# DART SERVICE INSTRUCTION

TO AMEND INSTALLATION INSTRUCTIONS: IIN-D206-667 REV. C  
 REF. CANADIAN STC: SH01-5  
 REF. FAA STC: SR01304NY

DESIGN	<i>[Signature]</i>	<b>DART AEROSPACE LTD</b>	
DRAWN	<i>[Signature]</i>	HAWKESBURY, ONTARIO, CANADA	
CHECKED	<i>[Signature]</i>	DRAWING NO.	REV. 1
MFG. APPR.	N/A	DSI 9346	SHEET 2 OF 2
APPROVED	<i>[Signature]</i>	TITLE	SCALE
DE APPR.	<i>[Signature]</i>	DEVIATION ON D206-667 & D407-667	NTS
DATE	09.10.08	COPYRIGHT © 2006 BY DART AEROSPACE LTD THIS DOCUMENT IS PRIVATE AND CONFIDENTIAL AND IS SUPPLIED ON THE EXPRESS CONDITION THAT IT IS NOT TO BE USED FOR ANY PURPOSE OR COPIED OR COMMUNICATED TO ANY OTHER PERSON WITHOUT WRITTEN PERMISSION FROM DART AEROSPACE LTD.

**FIGURE 1 - INSTALLATION OF DART CROSSTUBES ON BHT/AAI SKIDTUBE**

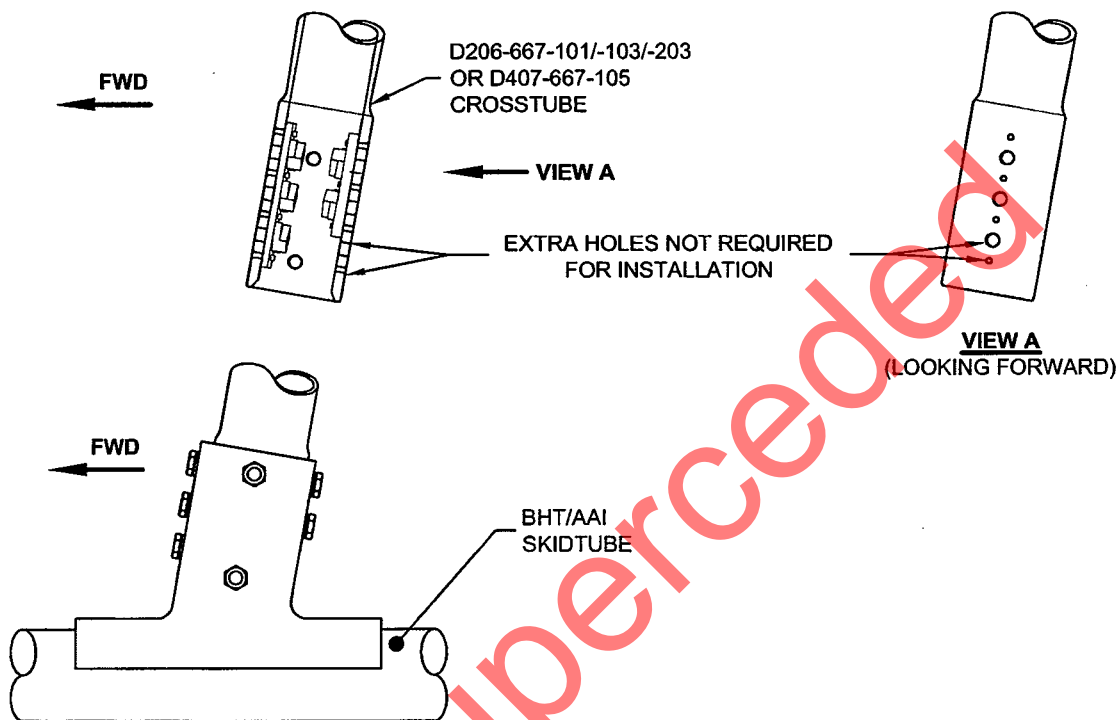
THE FOLLOWING D206-667-101/-103/-203 AND D407-667-105 CROSSTUBES HAVE EXTRA HOLES DRILLED ON THE AFT SIDE OF THE CUFFS. THIS HOLE IS NOT REQUIRED FOR INSTALLATION OF DART CROSSTUBES ONTO BHT/AAI SKIDTUBES AS SHOWN IN FIGURE 1.

CUSTOMERS RECEIVING CROSSTUBES AT CHG 002 PRIOR TO 06.08.08 SHOULD CONTACT DART FOR DISPOSITION IF INSTALLING THE DART CROSSTUBES ONTO BHT/AAI SKIDTUBES PER IIN-D206-667 REV. C.

CUSTOMERS RECEIVING CROSSTUBES AT CHG 002 PRIOR TO 06.08.08 TO BE INSTALLED WITH DART SKIDTUBES MAY FIND THAT THE SUPPORTS HAVE BEEN INSTALLED BACKWARDS. THE SUPPORTS SHOULD BE REMOVED AND RE-INSTALLED PER ICA-D206-667.
